**BID BULLETIN NO. 02**

**I. Attention is hereby invited to the Bidders of **LAOAG INTERNATIONAL AIRPORT DEVELOPMENT PROJECT CY 2022 & 2023 (IMPROVEMENT / EXPANSION OF PASSENGER TERMINAL BUILDING)** with Project Number: **Bid No. 23-036-10 ALPHA.****

- ☐ **Truss RT-02**  
☐ **Truss RT-04**

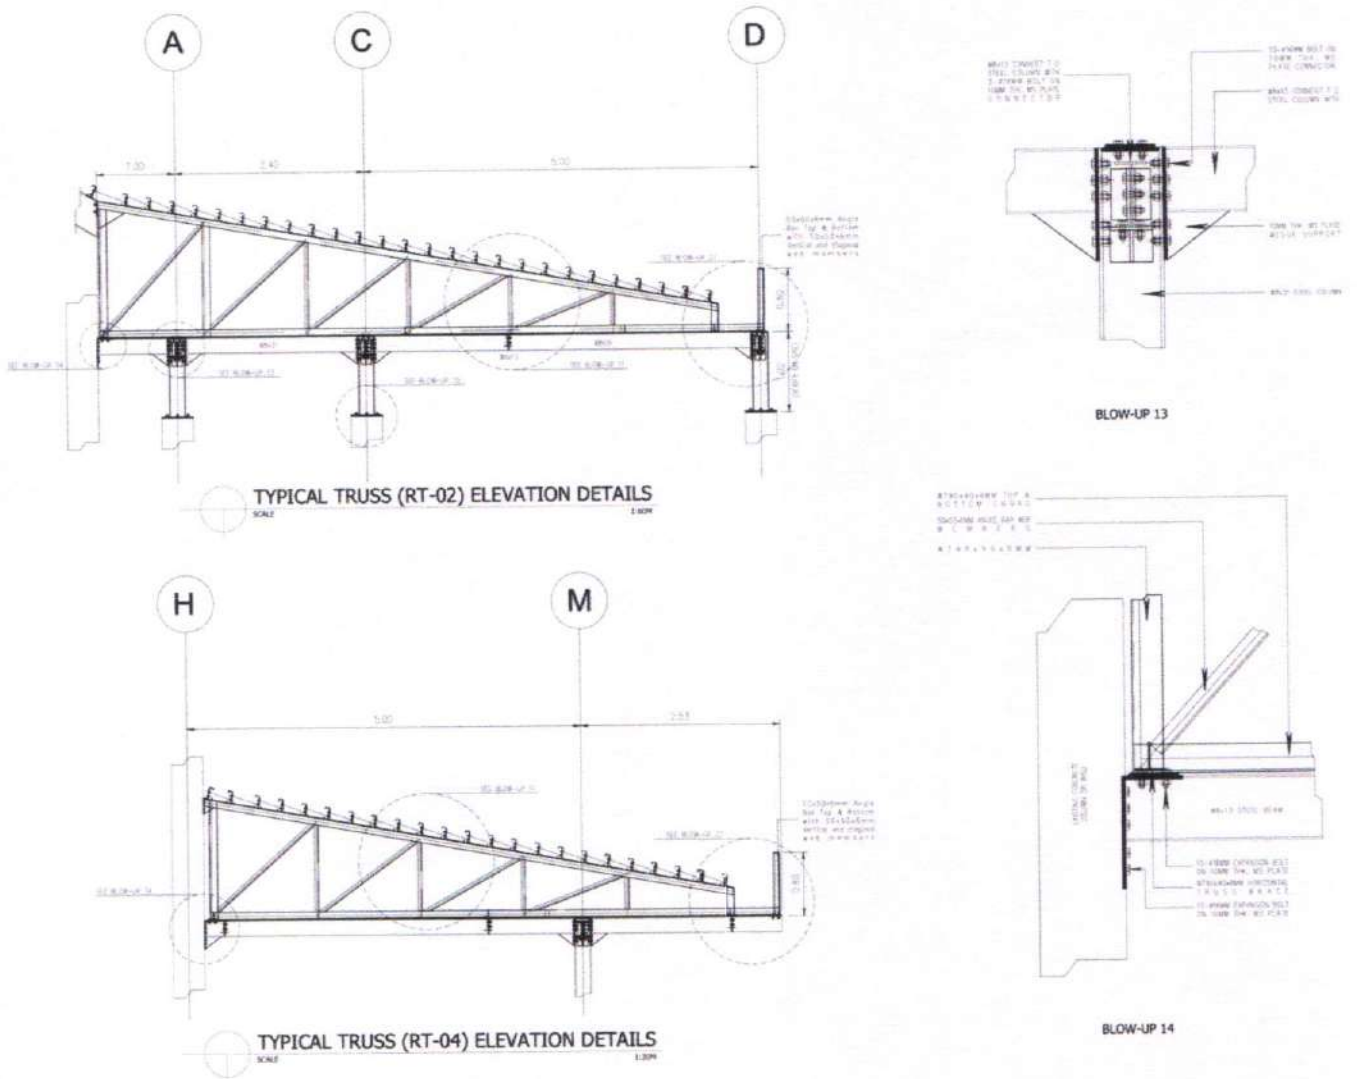
**Requesting to provide the sectional details of the following trusses:**

See attached supplemental plans of the Truss Elevation Details and Blow-Up Details (**Page 1**) for your reference.

BLOW-UP 15

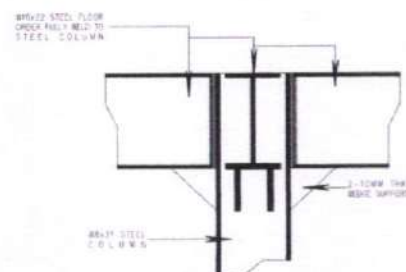
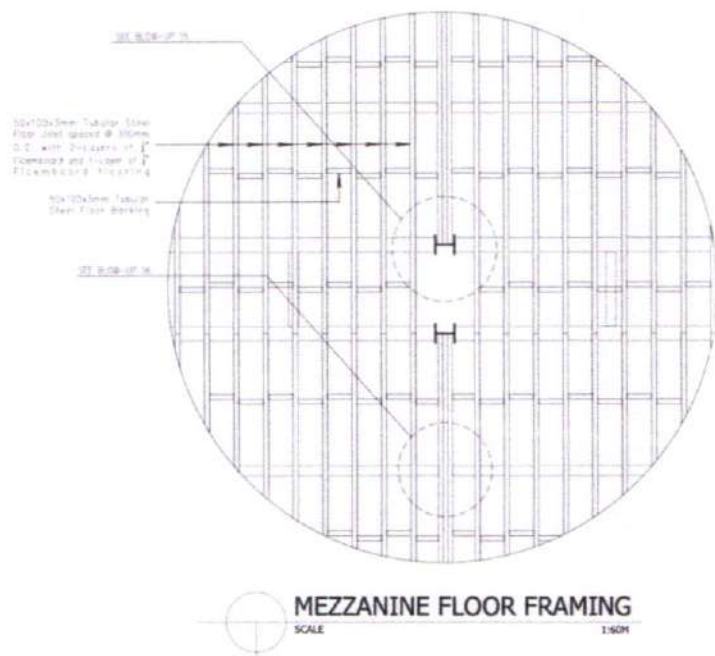
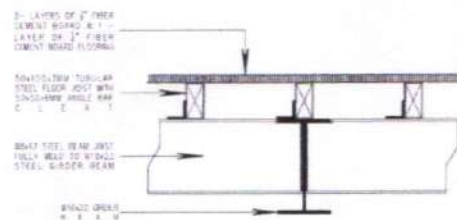
**Requesting to provide Structural/Sectional Details & Connection Details of Mezzanine Floor Framing.**

See attached supplemental plans of Mezzanine Floor Framing and Blow-Up Details (**Page 2**) for your reference.

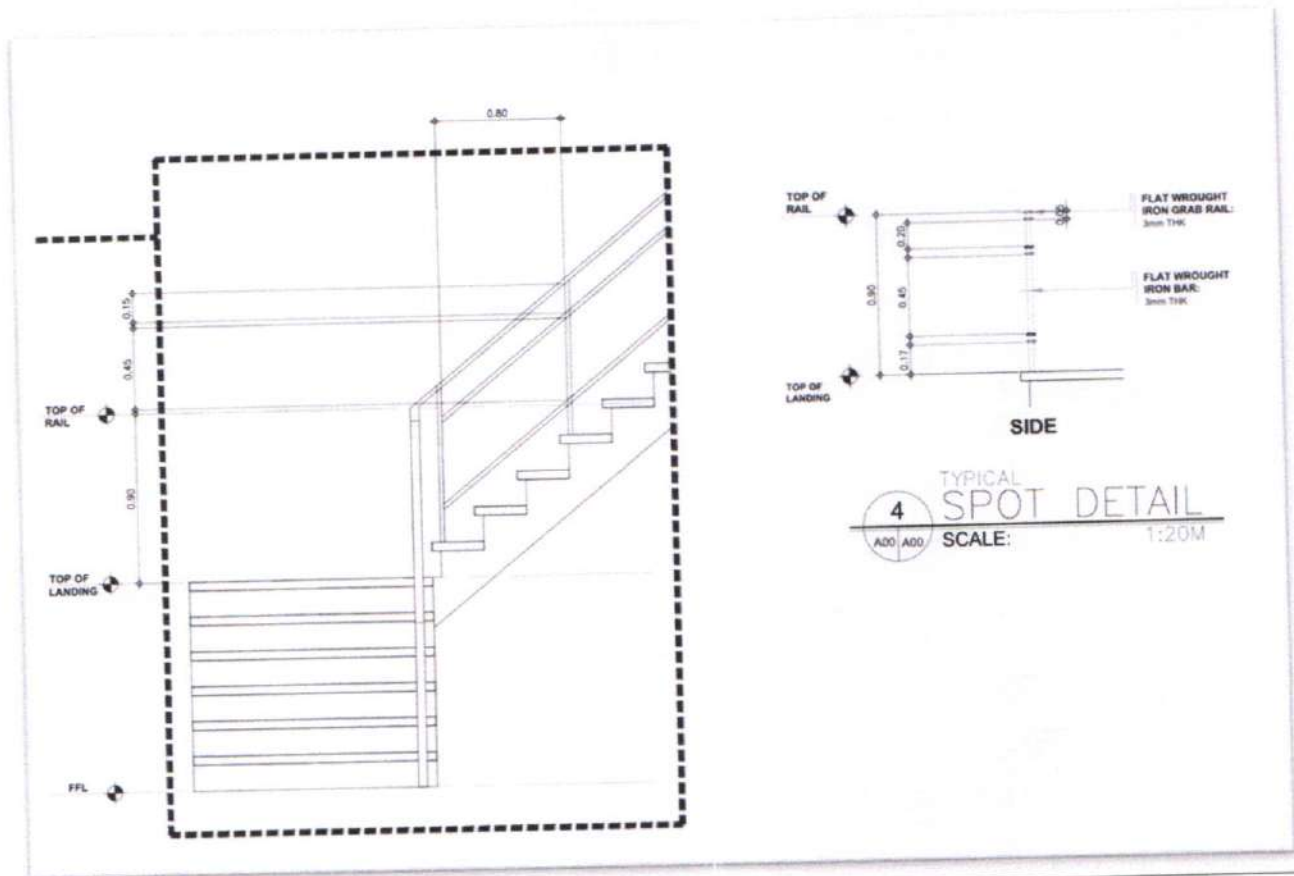
**Requesting to provide details of railings and balustrades at stairs.**

See attached supplemental plans for the Railings and Balustrades at Stairs (**Page 8**) for your information on the requested details.

(Item 9)

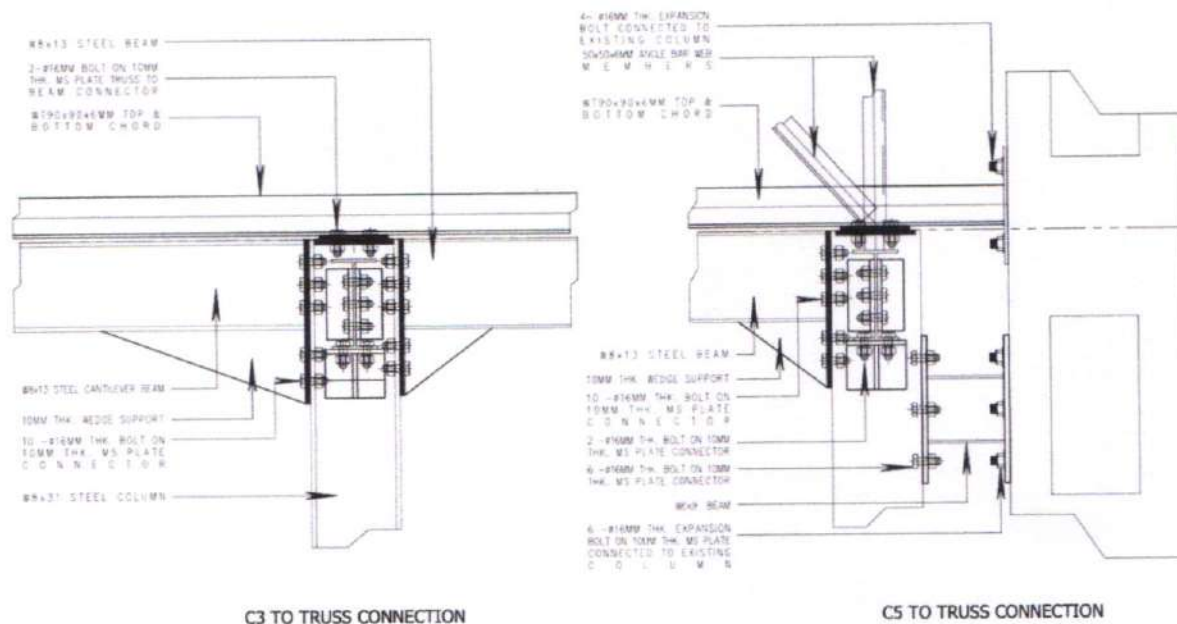
**Requesting to provide the following connection details of the highlighted areas:**

- ☐ **Column C3 to Existing Column**
- ☐ **Truss to Column C3**
- ☐ **Truss to Column C5**

See attached supplemental plans for the listed connection details (**Page 2**) for your reference.

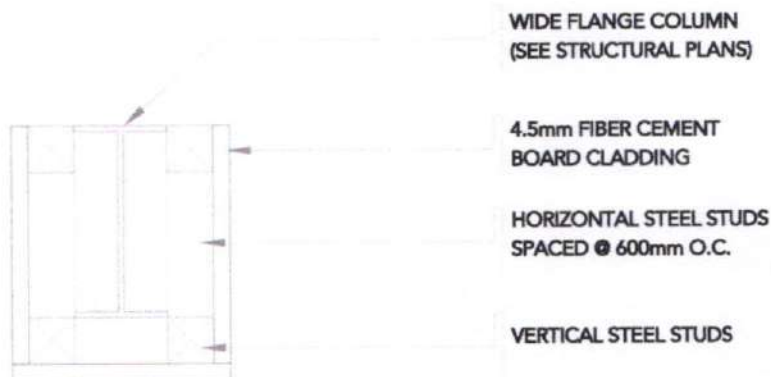
**Requesting to provide detailed plan/drawing column finishes.**

See attached supplemental detail regarding the requested column finish.

SKYLIGHT  
DETAILED SECTION  
SCALE: 1/8\"/>

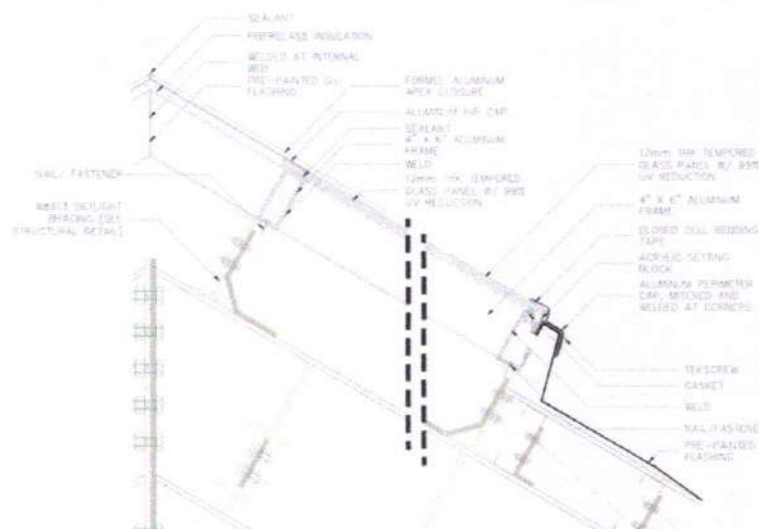
**Requesting to provide detailed plan/drawing of skylights.**

See attached supplemental plans for the requested Toilet Details (**Page 17**) for your reference.

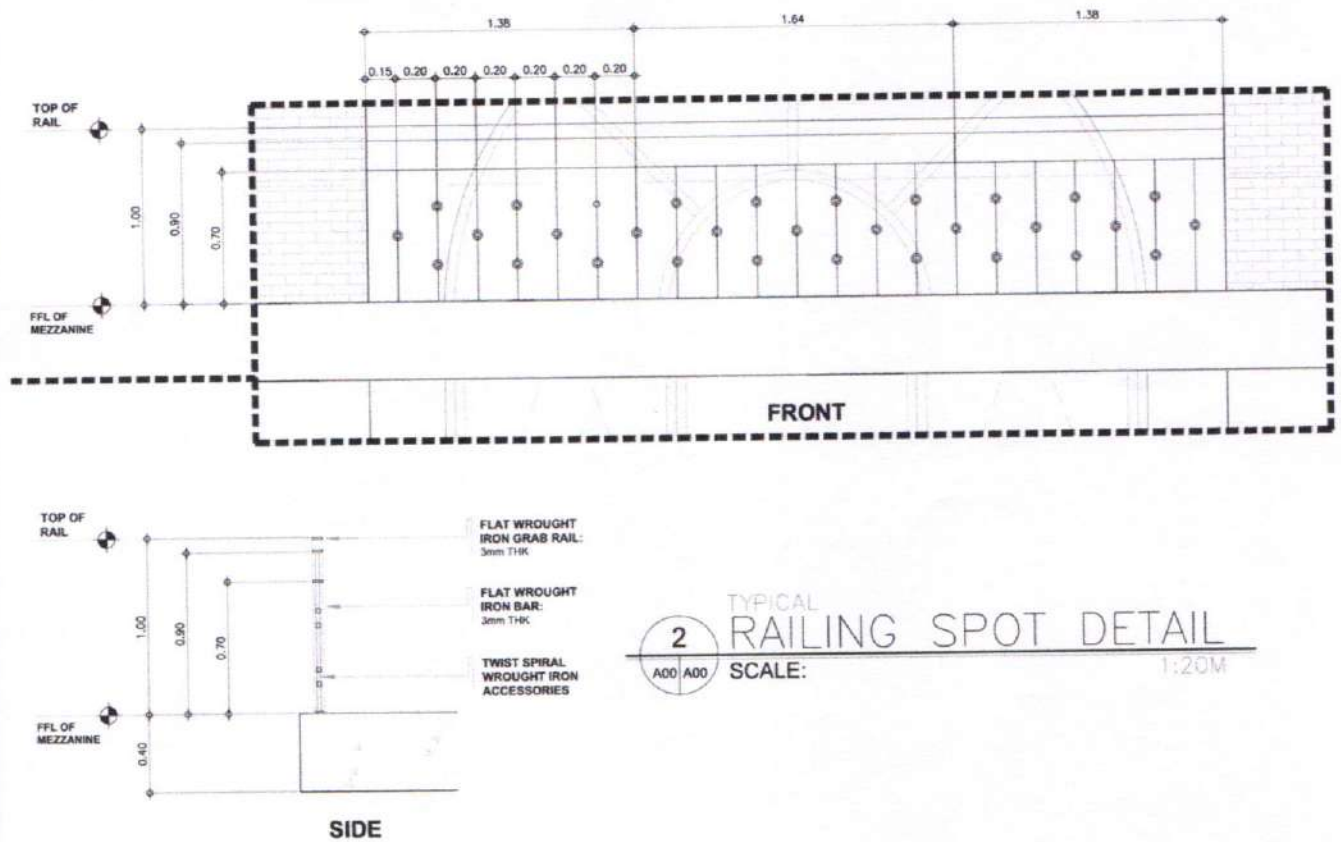
**Requesting to provide detailed plan/drawing of railing at Pre-Departure Area.**

See attached supplemental details of Railings and Balustrades at Pre-Departure Area (**Page 8**) for your reference.

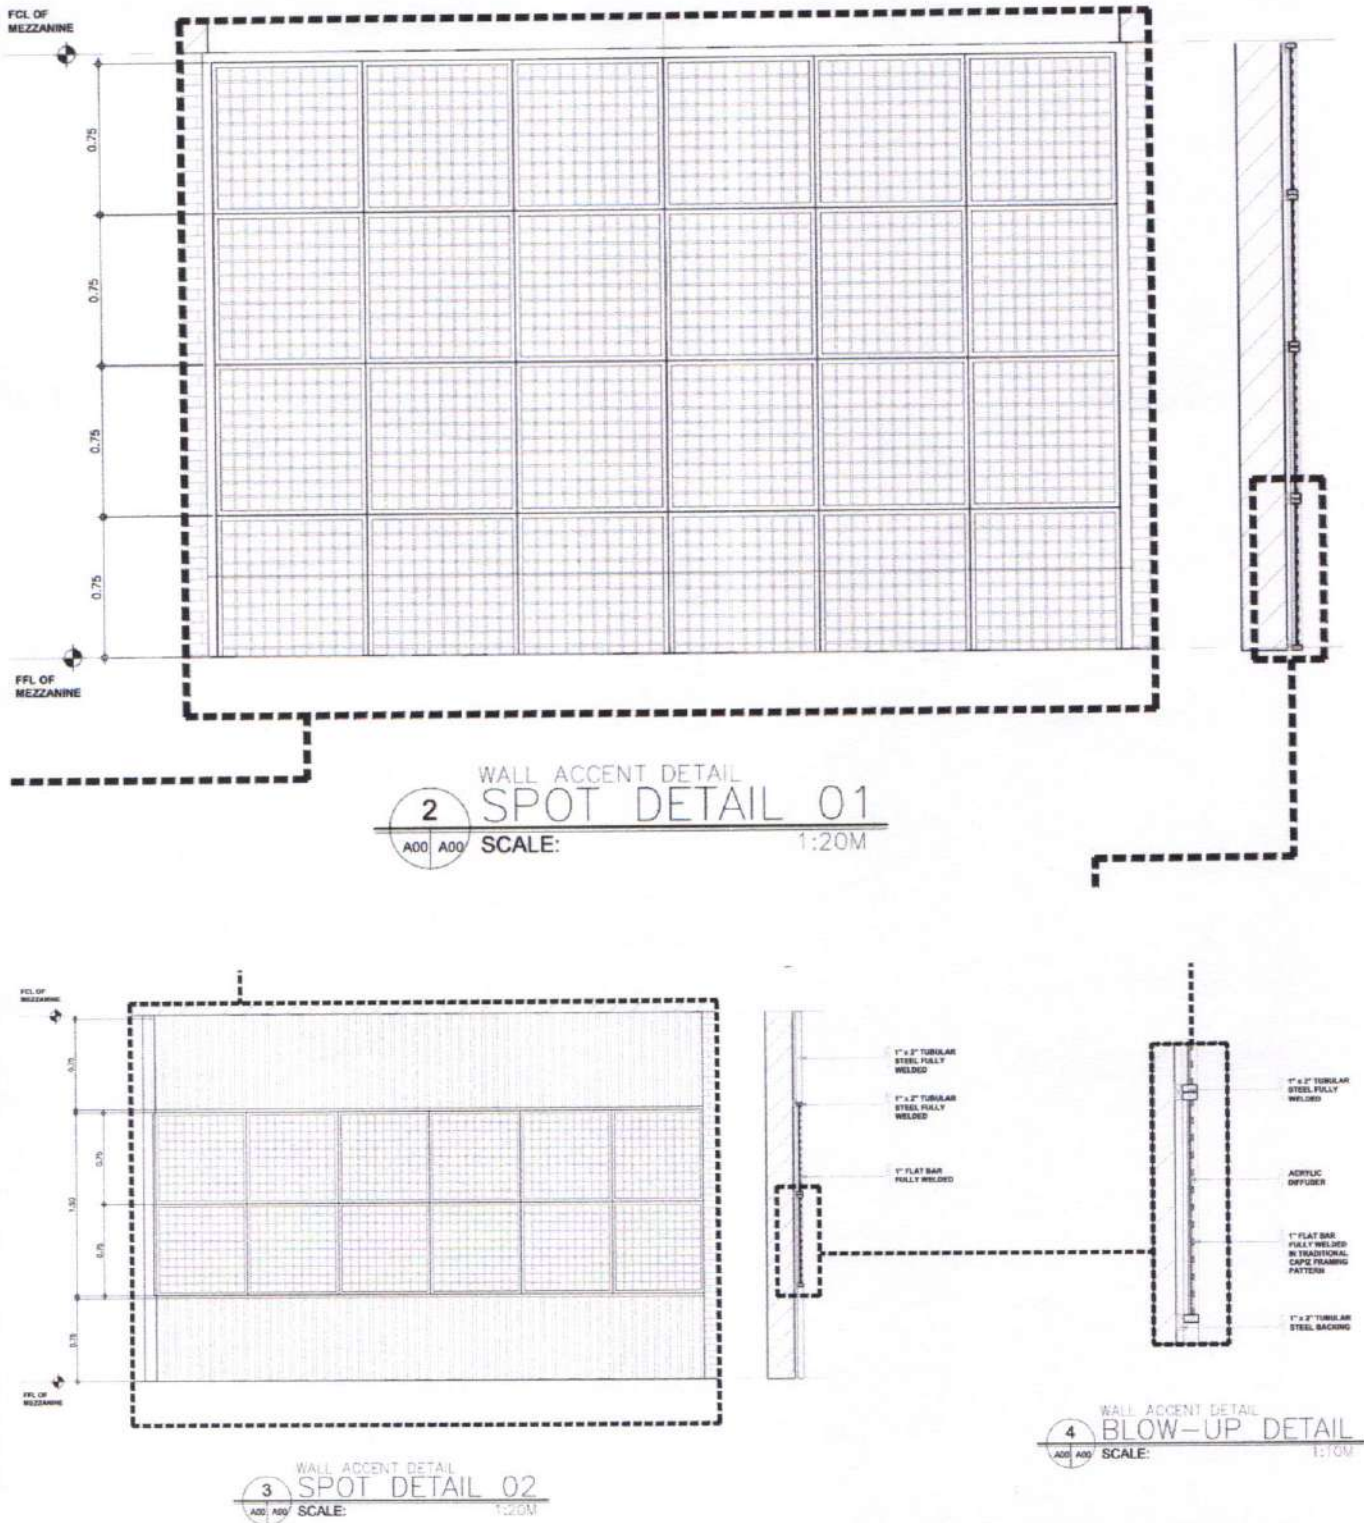
**Requesting to provide detailed plan/drawing of Wall Finishes at Arrival and Pre-Departure Area.**

See attached supplemental details of Wall Finishes (**Page 18**) for your reference on the requested document.

**TR-01 DETAILS**

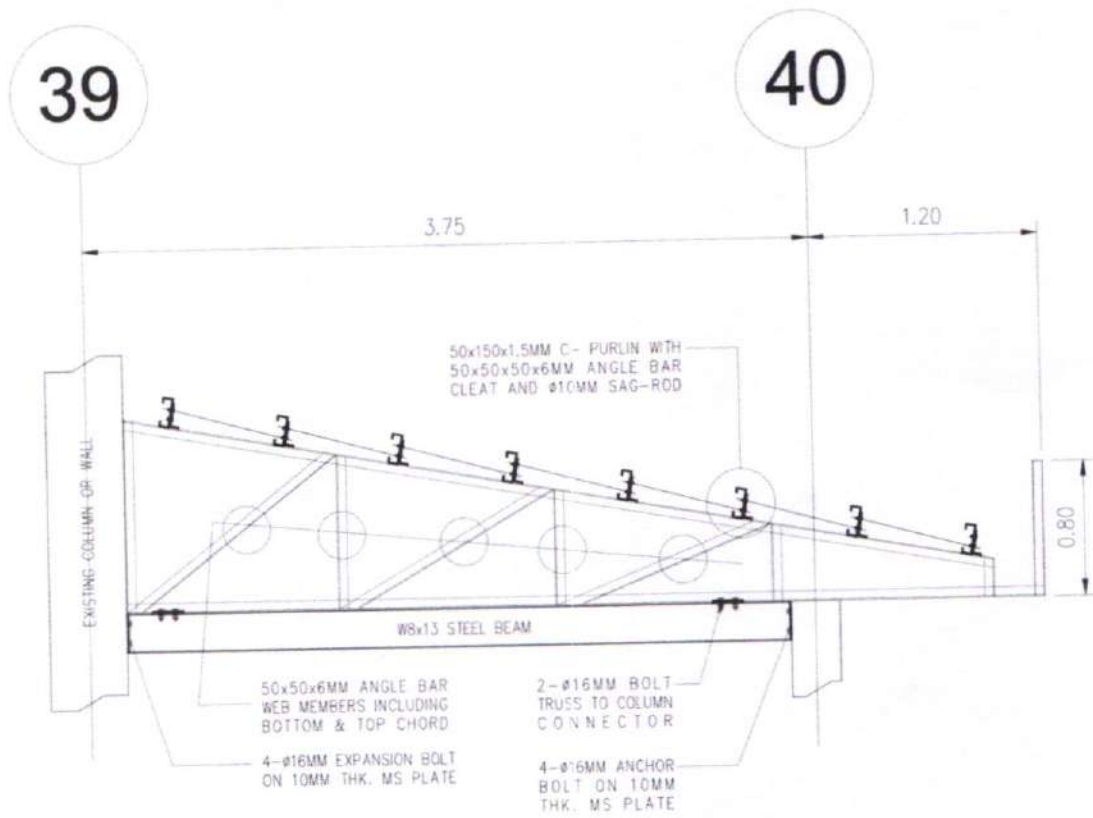
**Requesting to provide the framing details of Roof at Gridline 39-40/D-1**

- ☐ **Truss TR-01**
- ☐ **Connection Details**

See attached supplemental plan of the Truss Detail (**Page 2**) for your reference.

**Structural Plans > S-15 > Blow-Up 7**

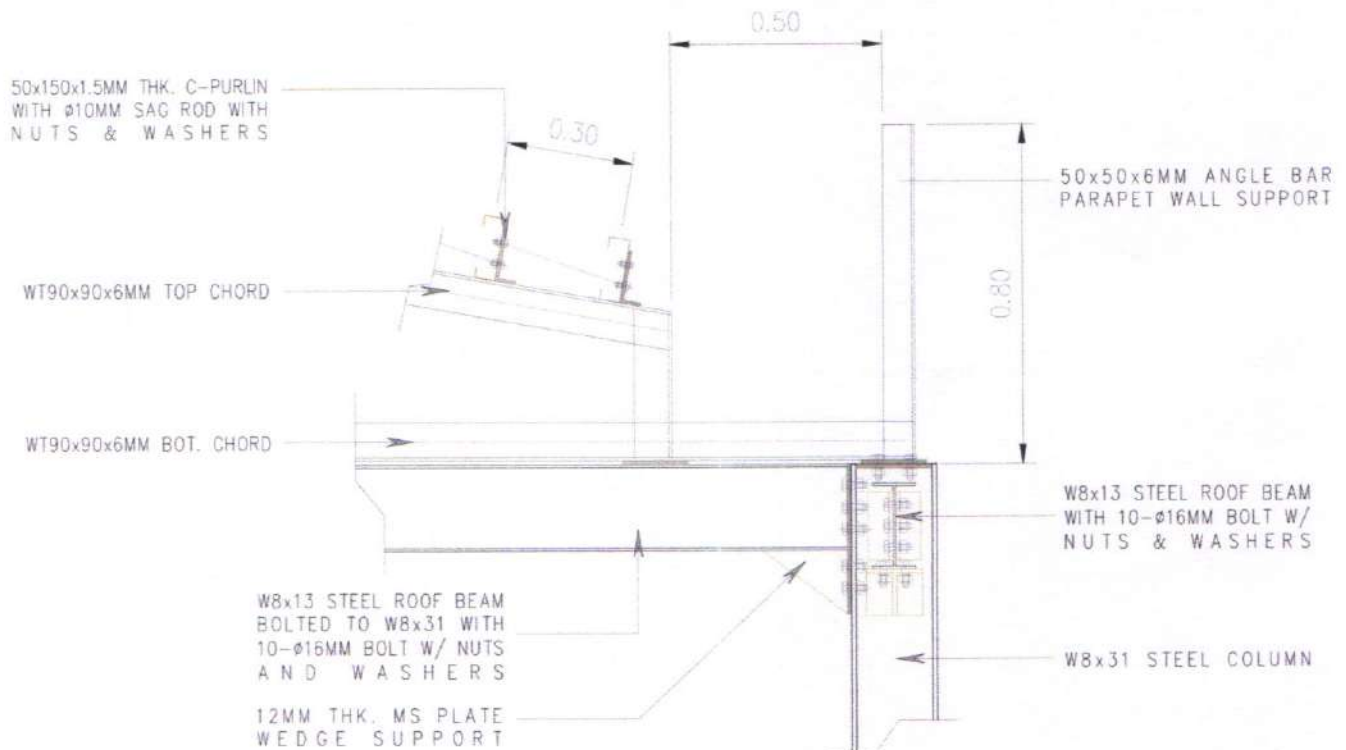
**Requesting to provide connection details of Structural Steel Framing at Elev 5.0m.**

Connection details were already provided with the approved Detailed Engineering Drawings (S-15). Kindly refer to the attached Blow-Up Detail for your clarification. Approved Detailed Engineering Drawings can be accessed through this link:
